FILE P.I. #610750-
IM000-0075-03(189)
GDOT District 6 - Cartersville
Gordon County
I-75 @ SR 156

SUBJECT **APPROVED REVISED PROJECT CONCEPT REPORT**

**DEPARTMENT OF TRANSPORTATION
STATE OF GEORGIA
REVISED PROJECT CONCEPT REPORT**

Project Number: IM000-0075-03(189)

**TYPICAL SECTION NO. 1
TANGENT SECTION - WIDENING AND OVERLAY
SR 156 / REDBUD ROAD**

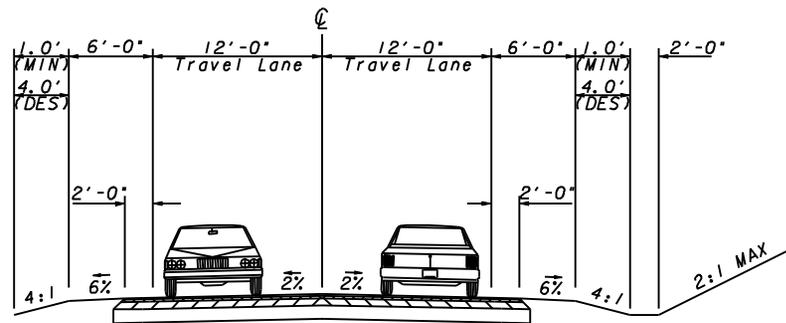
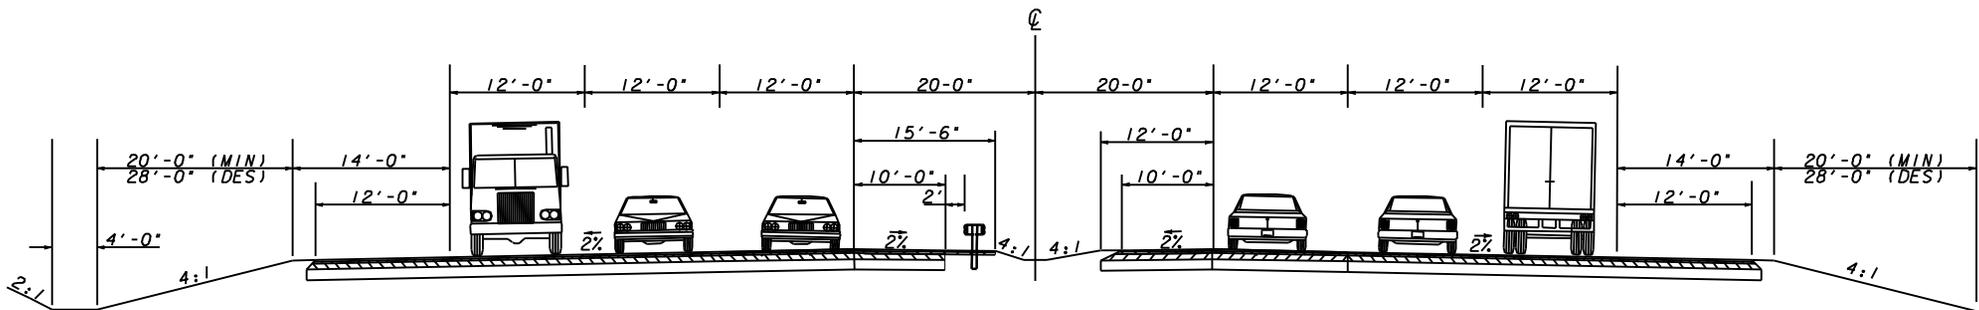
The variable raised median as approved in the project concept is proposed to be changed to a 14 ft. flush median. A design variance has been approved to reduce the required minimum limited access. Columbus Circle Extension is proposed to be eliminated from the project.

<p>Approved Features:</p> <p>1. Typical Section The approved project concept proposes a variable width (20 ft. to 32 ft.) 6 in. high raised concrete median for SR 156/Redbud Road.</p> <p>2. Access Control The approved project concept proposes limited access controlled 100 ft. beyond each ramp radius point along SR 156/Redbud Road.</p> <p>3. Project Scope The approved project concept proposes the construction of Columbus Circle Extension to Warrior Path.</p>	<p>Proposed Features:</p> <p>1. Typical Sections It is proposed that SR 156/Redbud Road will provide a 14 ft. flush median, except at the following three locations, where a raised concrete median will be constructed.</p> <ul style="list-style-type: none"> • West of the I-75/SR156 interchange from station 22+39 to station 24+67, approximately 228 ft. long and 10 ft. to 28 ft. wide. • At the interchange from station 25+77 to station 29+87, approximately 410 ft. long and 4 ft. wide. • East of the I-75/SR156 interchange from station 30+94 to station 33+73, approximately 279 ft. long and 28 ft. to 10 ft. wide. <p>2. Access Control There is an approved project design variance that proposes limited access control ending 167 ft. east of the northbound ramp (north side of SR 156), 228 ft. east of the northbound ramp (south side of SR 156), and 282 ft. west of the southbound ramp (both sides of SR 156).</p> <p>3. Project Scope It is proposed to eliminate the construction of Columbus Circle Extension.</p>

<p>Reasons for Change:</p> <p>1. Design year traffic volumes do not currently warrant a raised median. The proposed typical section provides for conversion to a 20 ft. raised median once traffic volumes warrant.</p> <p>2. A design variance was approved to break the current policy for the following reasons: (1) the current typical section constructs a raised median which restricts left turns within the minimum 300 ft. limited access area at the ramps and will help enhance the operations in the interchange area; (2) extending the limits of access along SR 156 for a distance of 300 ft. will require an additional estimated \$701,000 in damages, additional impacts to properties plus damages that could be awarded in condemnation of the Waffle House parcel.</p> <p>3. The construction of Columbus Circle Extension is no longer justified due to the proposal of the flush median on SR 156/ Redbud Road.</p>

PROJECT IM000-0075-03(189)
 GORDON COUNTY
 13-03

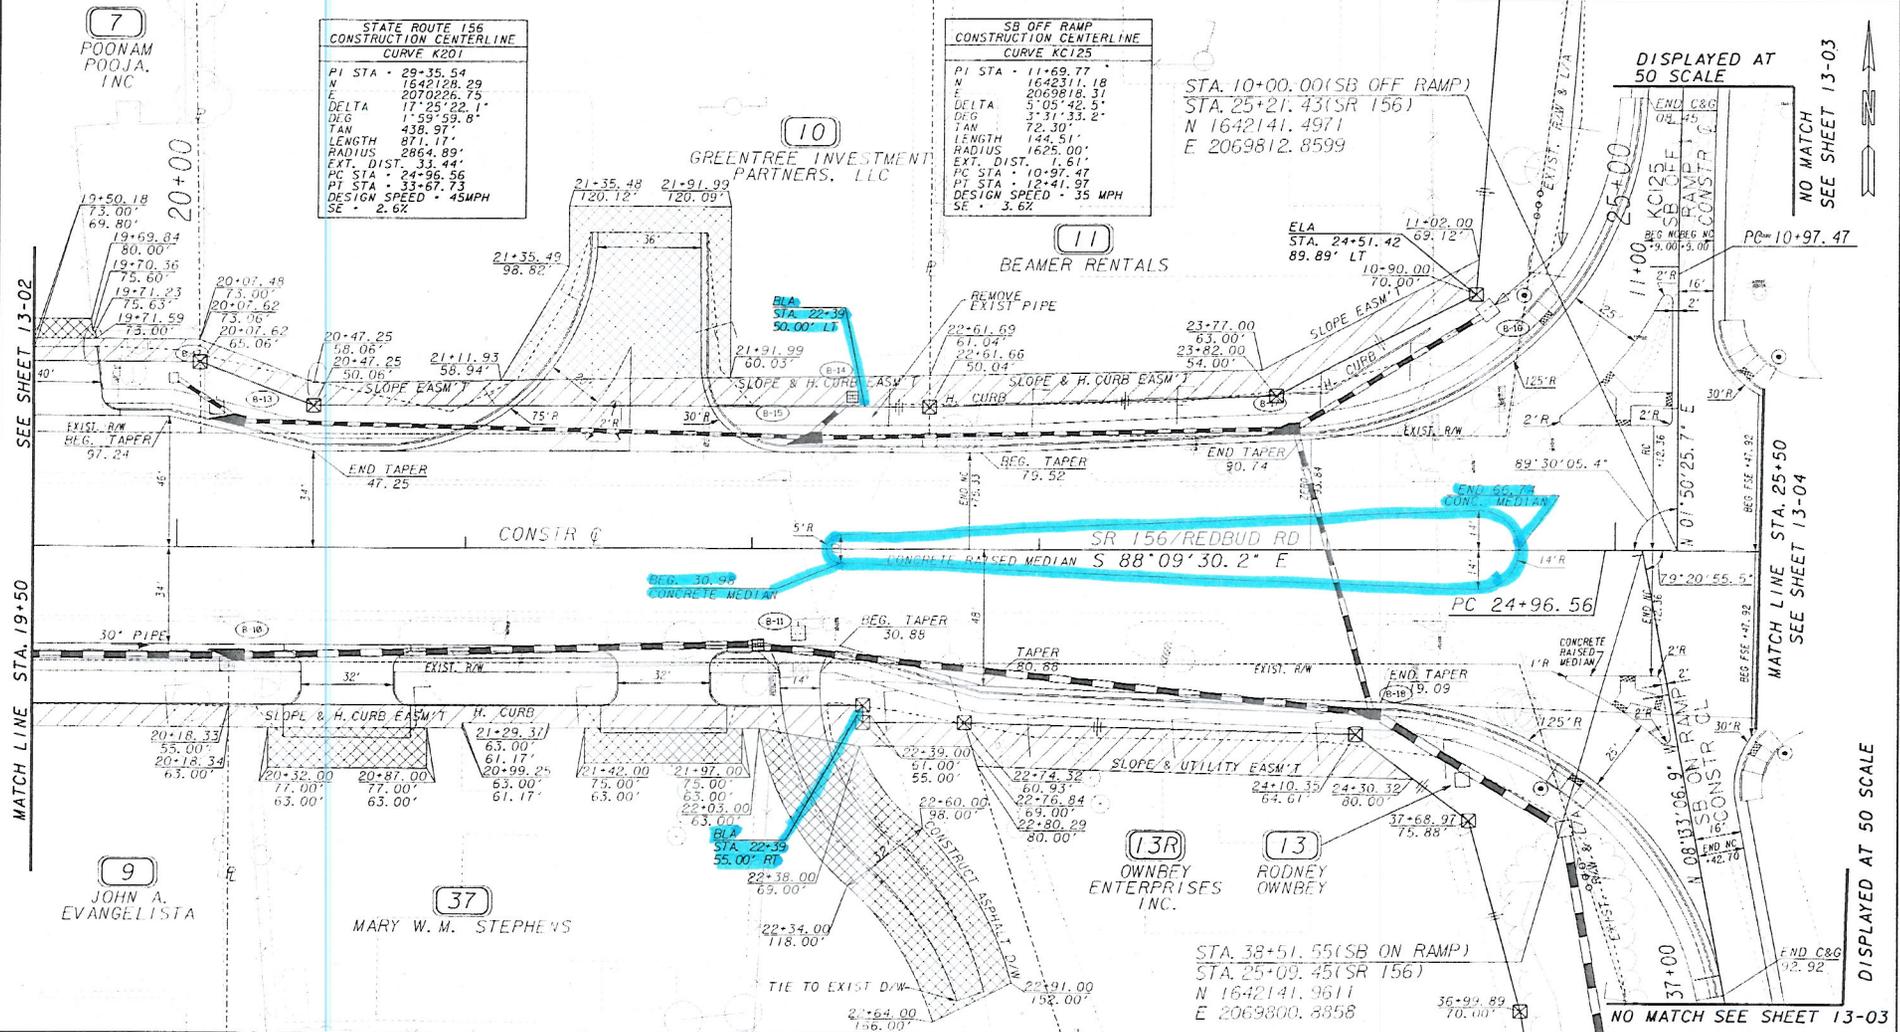
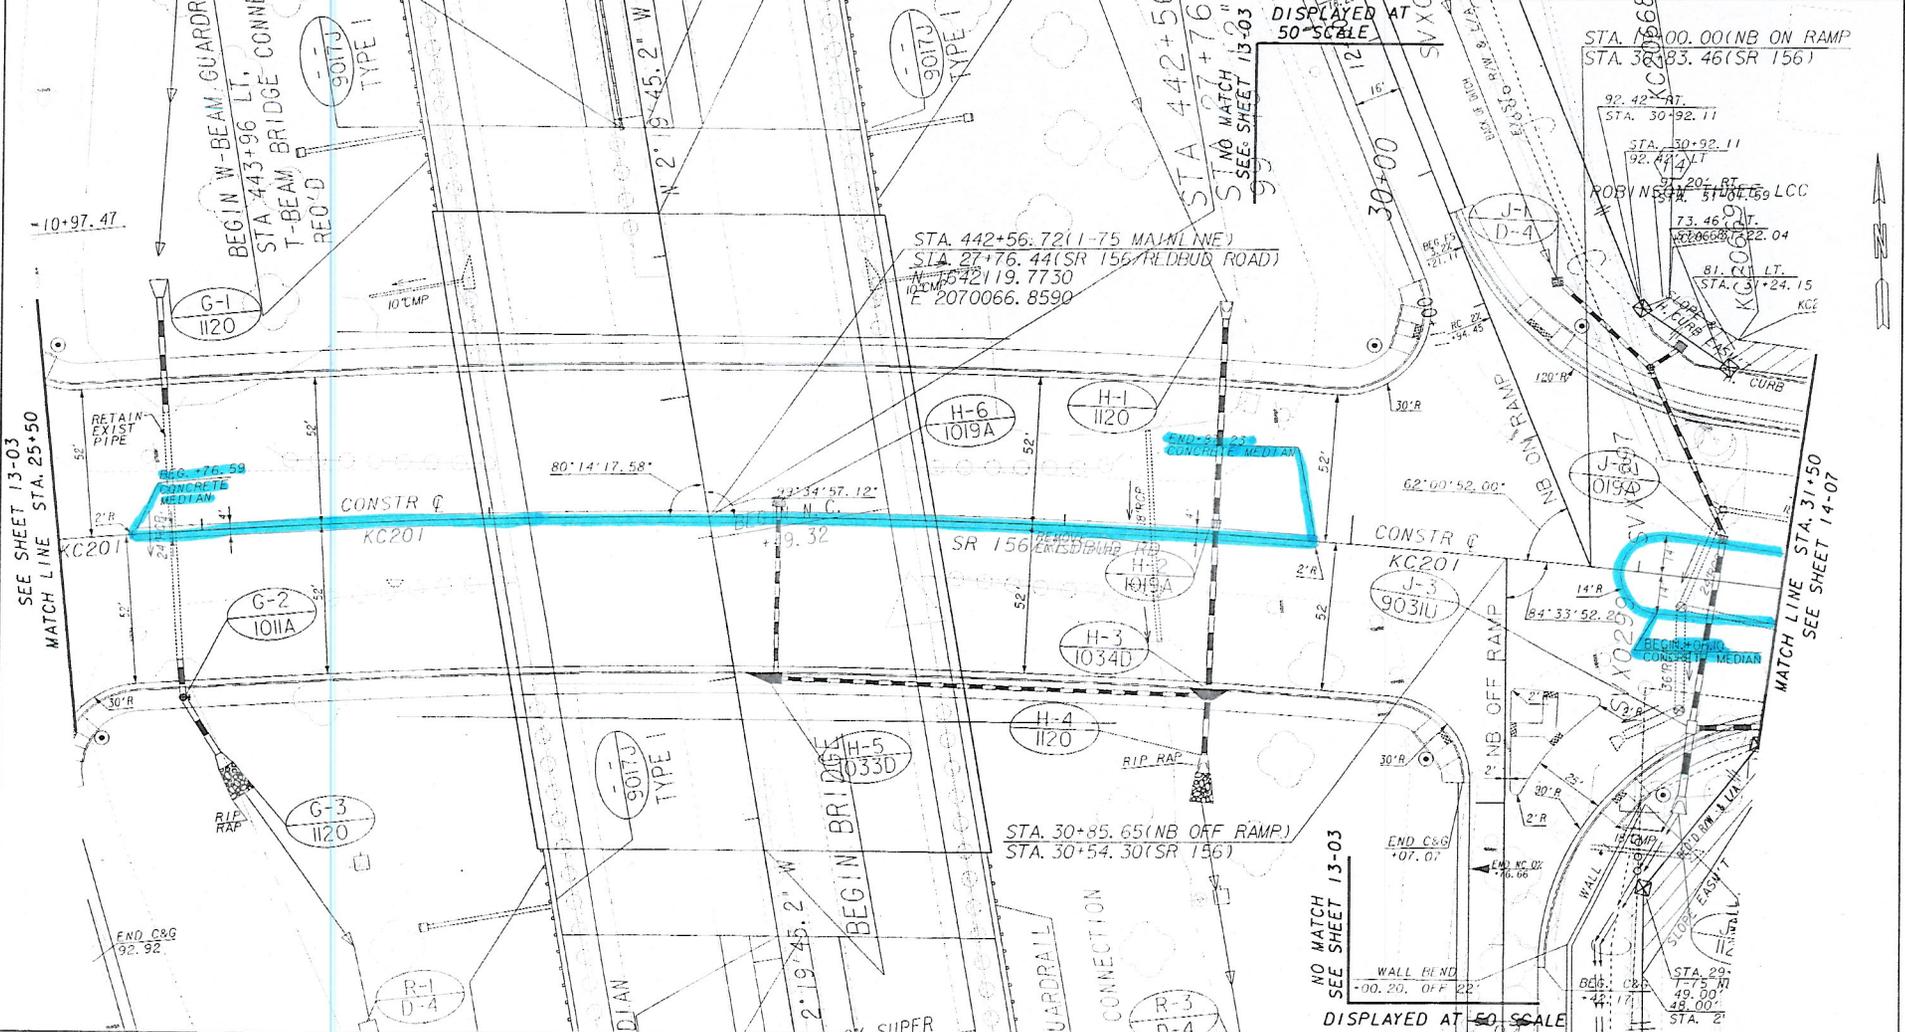
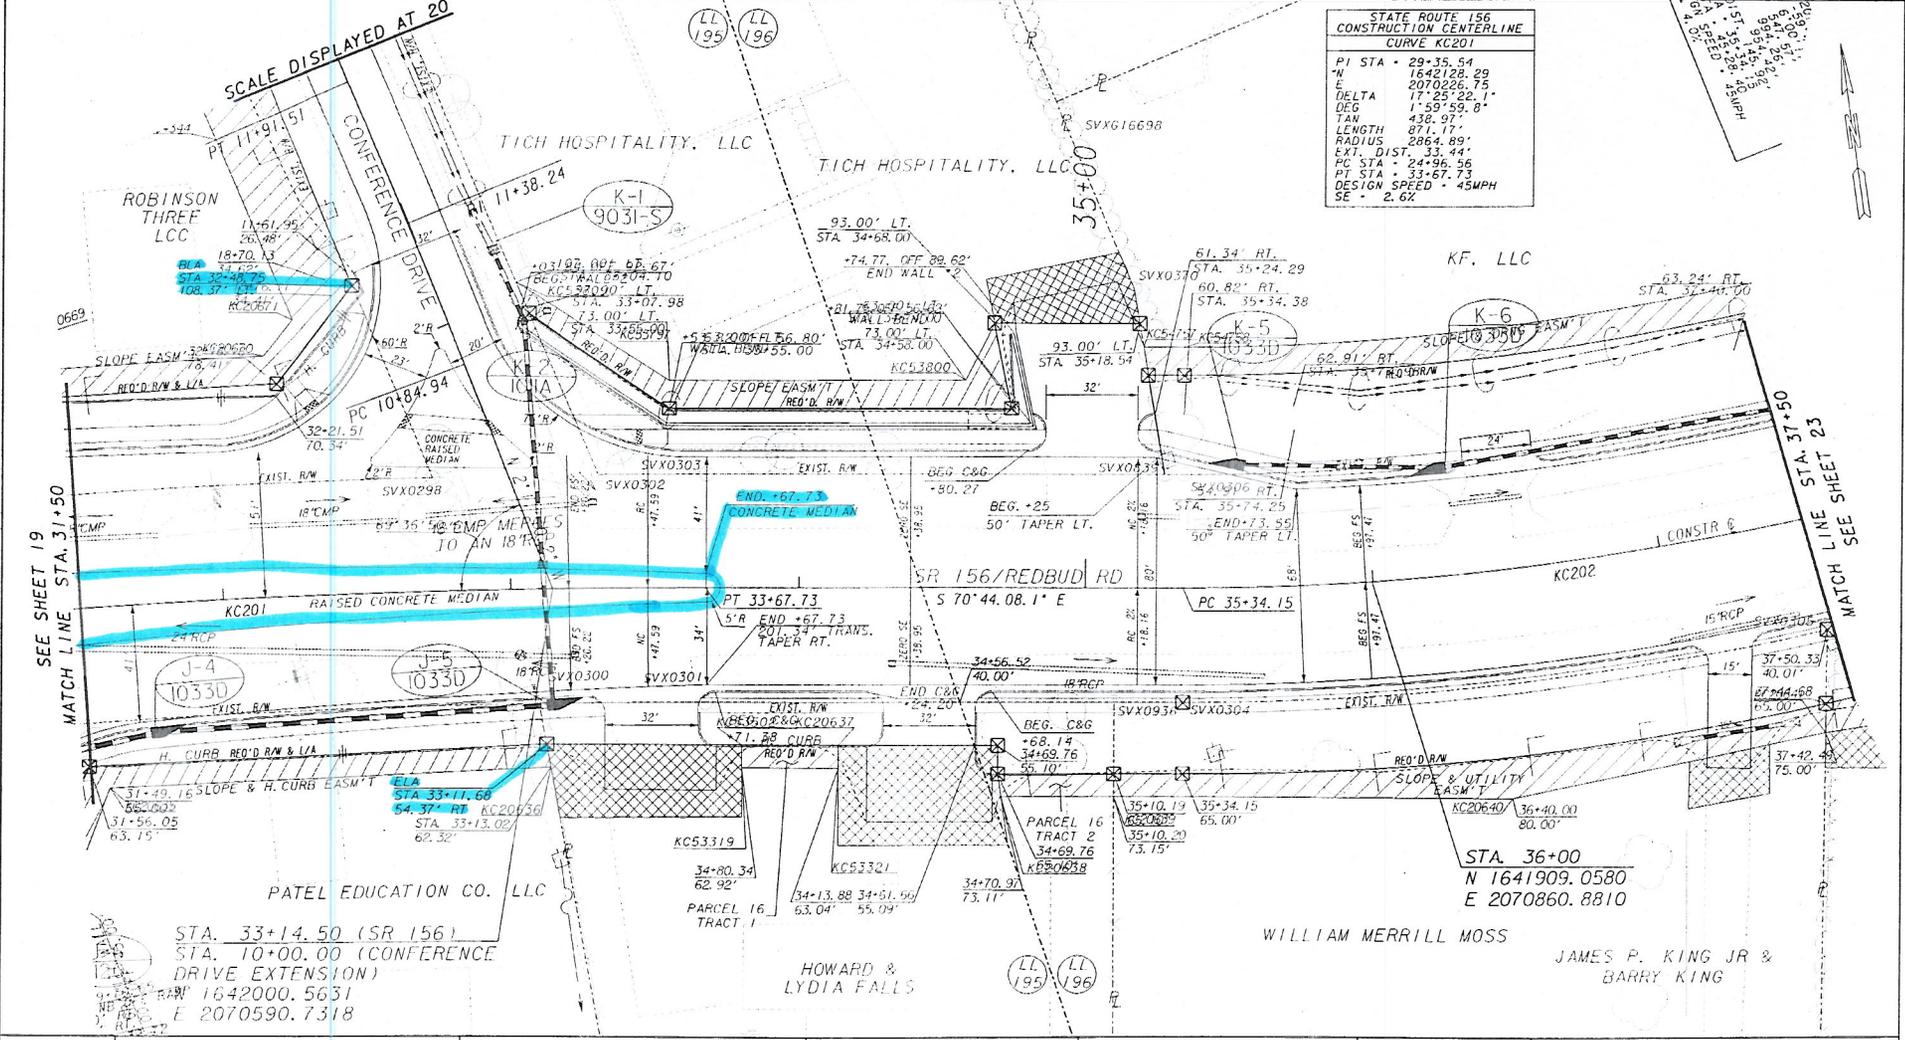
This request for Design Variance involves access rights along SR 156 east of the I-75 northbound ramp and west of the I-75 southbound ramp. According to current policy (TOPPS 4A-3, dated 09/30/2005) Access Control will be established along the intersecting route for a minimum of 300 feet from the intersection of the ramp centerline with the crossroad centerline. The current design proposes a limited access 167 feet east of the northbound ramp (north side SR 156), 228 feet east of the northbound ramp (south side SR 156), and 282 feet west of the southbound ramp (both sides of SR 156).

In order to meet the current policy for access rights along the south side of SR 156 at the northbound I-75 ramps, it would be necessary to eliminate the westernmost driveway for Parcel 16 (Calhoun Antique Mall). The value of the estimated damages is \$120,000.

Also, to meet the current policy for access rights along the north side of SR 156 at the northbound I-75 ramps, it would be necessary to close Adventist Drive at SR 156. This would restrict access to parcel 38 (Waffle House Restaurant) by requiring a 0.55 mile detour via Red Bud Road, Newtown Road, and Adventist Road Extension. Loss of direct access from SR 156 to the Waffle House will likely result a required condemnation of the Waffle House property and additional damages could be awarded.

Again, in order to meet the current policy for access rights along the south side of SR 156 at the southbound I-75 ramps it would be necessary to eliminate a residential driveway for the residence for Parcel 37, a 14.5 acre tract on the south side of SR 156. This would require providing access to this residence through the commercial frontage of Parcel 37. The value of the estimated damages is \$581,000.

A marked plan sheet showing the Required Limits of Access is attached.

It is recommended that a design variance be approved for the following reasons: (1) the currently proposed design constructs a raised median on SR 156 at the northbound ramp (284 feet east of the ramp centerline) and southbound ramp (290 feet west of the ramp centerline) which restricts left turns within the desired 300 feet limited access area at the ramps and will help enhance the operations in the interchange area; (2) extending the limits of access along SR 156 for a distance of 300' from the ramp centerlines will require an additional estimated \$701,000 in damages, additional impacts to properties plus damages that could be awarded in condemnation of the Waffle House parcel.
